ASB-1005

Service Bulletin

Subject: TM-732A/E Change in Chip Fuse Rating
1993

TX-RX Unit 430 MHz
(X57-4000 B/4)
Foil side.

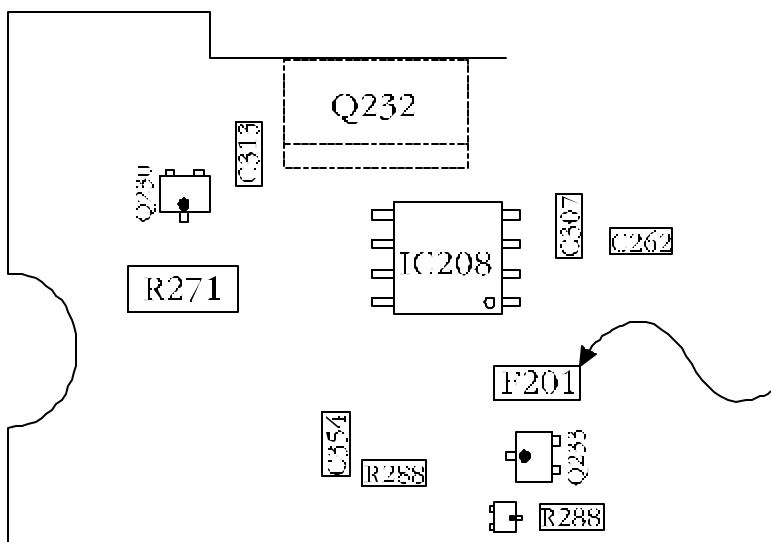
Change the chip fuse from 1A to 1.2A in the 430 MHz Unit (X57-4000-11 B/4) whenever servicing this board.

Qty	Description	Kenwood Part No.	Circuit Description
1	Chip Fuse, 1.2 Amp	F53-0095-05	F201
